# HISTORIC AND DESIGN REVIEW COMMISSION

**HDRC CASE NO:** 2022-345  
**ADDRESS:** 305 LAVACA ST  
**LEGAL DESCRIPTION:** NCB 708 BLK 8 LOT 2  
**ZONING:** RM-4, H  
**CITY COUNCIL DIST.:** 1  
**DISTRICT:** Lavaca Historic District  
**APPLICANT:** Caroline Gado  
**OWNER:** Leslie Jones/1918 MLK DEVELOPMENT GROUP LLC  
**TYPE OF WORK:** New construction of two, 2-story duplex structures  
**APPLICATION RECEIVED:** September 28, 2022  
**60-DAY REVIEW:** Not applicable due to City Council Emergency Orders  
**CASE MANAGER:** Rachel Rettaliata

The applicant is requesting conceptual approval to construct two, 2-story duplex structures at 305 Lavaca.

3 SITE PLAN  
3/32" = 1'-0"

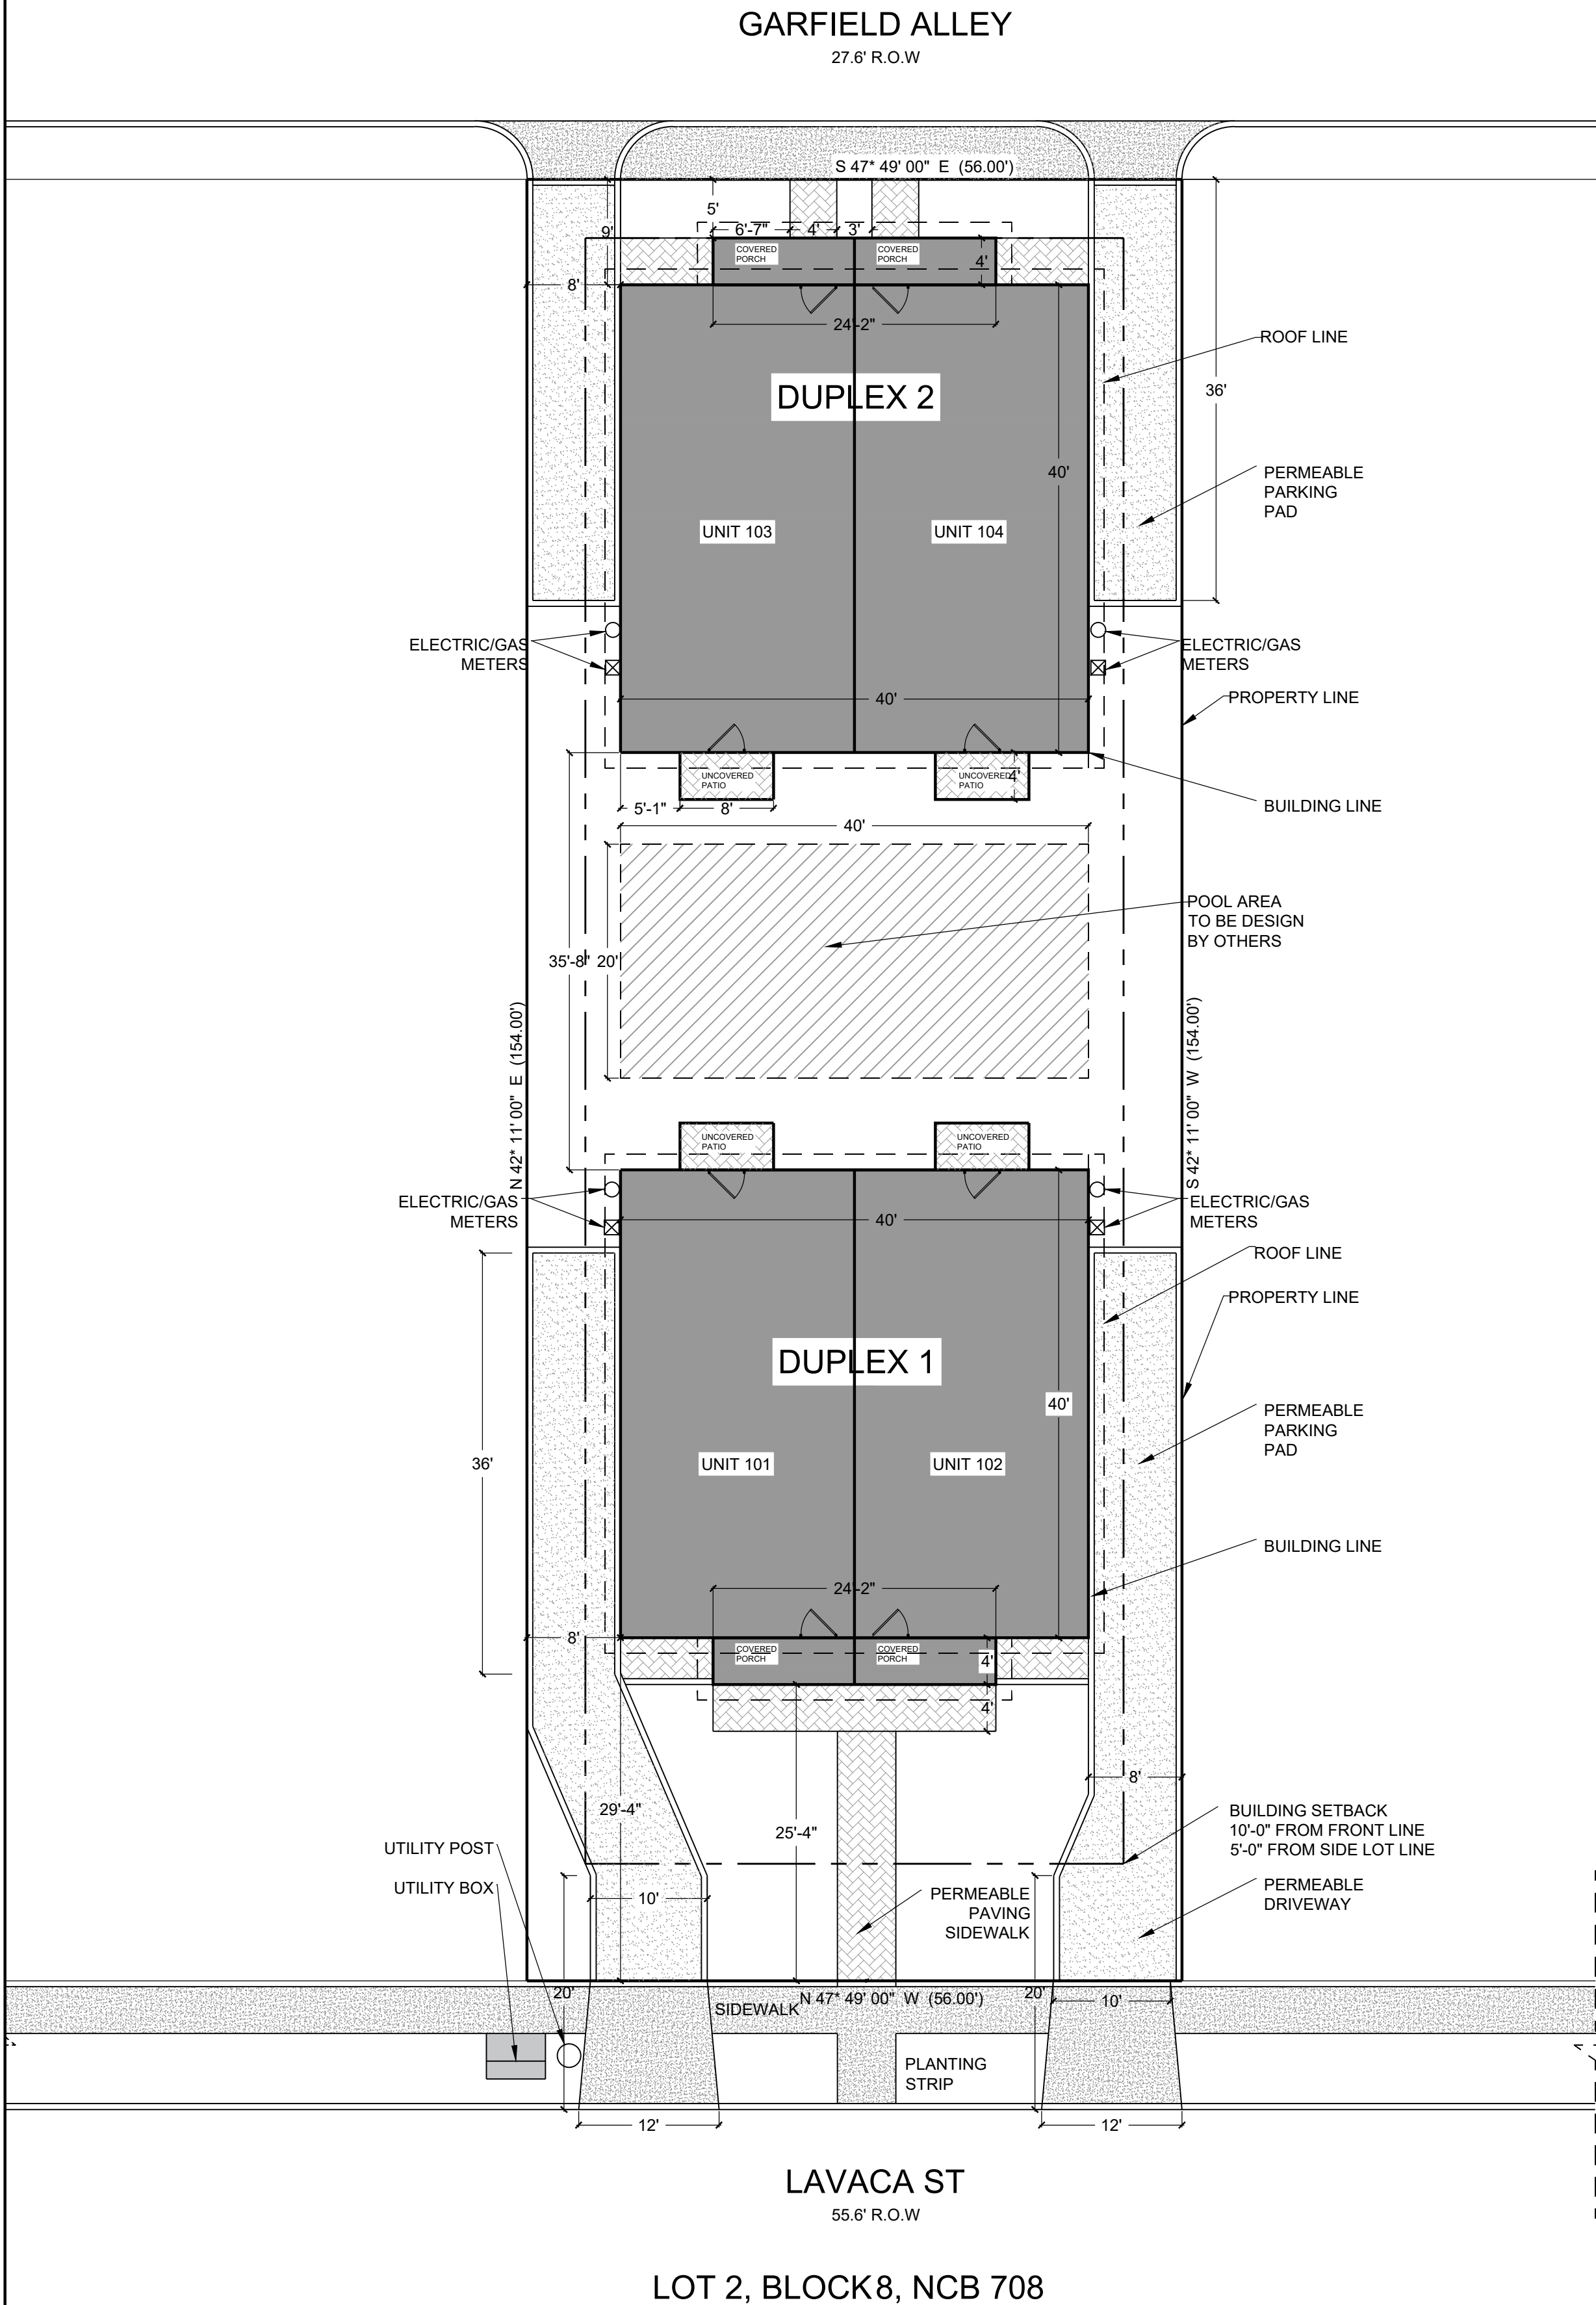
- d. SETBACK & ORIENTATION (LAVACA) – According to the Guidelines for New Construction, the front facades of new buildings should align with the front facades of adjacent buildings where a consistent setback has been established along the street frontage. Additionally, the orientation of new construction should be consistent with the historic examples found on the block. The applicant has proposed to construct two 2-story, duplexes residences at 305 Lavaca. The residences will be detached, with one duplex entrance facing Lavaca and the other duplex entrance facing Garfield Alley. The applicant has noted that the proposed setback from Lavaca will be 15 feet. The Historic Design Guidelines for New Construction stipulate that primary building entrances should be oriented towards the primary street and that front facades should be aligned with the front facades of adjacent buildings. Historically, homes have had frontage on both Lavaca and Garfield Alley. Staff finds that the applicant should provide a setback diagram noting the setbacks of neighboring structures.

- e. SETBACK & ORIENTATION (GARFIELD ALLEY) – According to the Guidelines for New Construction, the front facades of new buildings should align with the front facades of adjacent buildings where a consistent setback has been established along the street frontage. Additionally, the orientation of new construction should be consistent with the historic examples found on the block. The applicant has noted that the proposed setback from Garfield Alley will be 5 feet. Staff finds that the applicant should provide a setback diagram noting the setbacks of neighboring structures.

- j. **LOT COVERAGE** – Guideline 2.D.i for New Construction stipulates that building to lot ratio for new construction should be consistent with adjacent historic buildings. Limit the building footprint for new construction to no more than 50 percent of the total lot area, unless adjacent historic buildings establish a precedent with a greater building to lot ratio. The applicant has expressed that each duplex will total 1,696 square feet and the proposed lot coverage will be 39.4 percent. Staff finds the proposal appropriate.

- q. FRONT WALKWAYS – The Guidelines for Site Elements note that front yard sidewalk should appear similar to those found historically within the district in regard to their materials, width, alignment and configuration. The applicant has proposed to install a 5-foot-wide front walkway constructed of permeable pavers and a 4-foot-wide walkway constructed of permeable pavers along the length of the west property line. The submitted site plan does not feature a front walkway for the duplex oriented toward Garfield Alley. Staff finds that the applicant should reduce the proposed front walkway to feature a width of four feet and that rear access to the pool and central common space should be utilized in lieu of the proposed walkway on the west property line.

- vii. That the applicant reduces the width of the proposed front walkway to four feet and that rear access to the pool and central common space should be utilized in lieu of the proposed walkway on the west property line based on finding q. The applicant must submit an updated site plan to staff for review prior to returning to the HDRC.

- i. That the applicant provides a setback diagram showing that the proposed structure will not be located in front of the front façade wall planes of adjacent historic structures based on findings d and e.
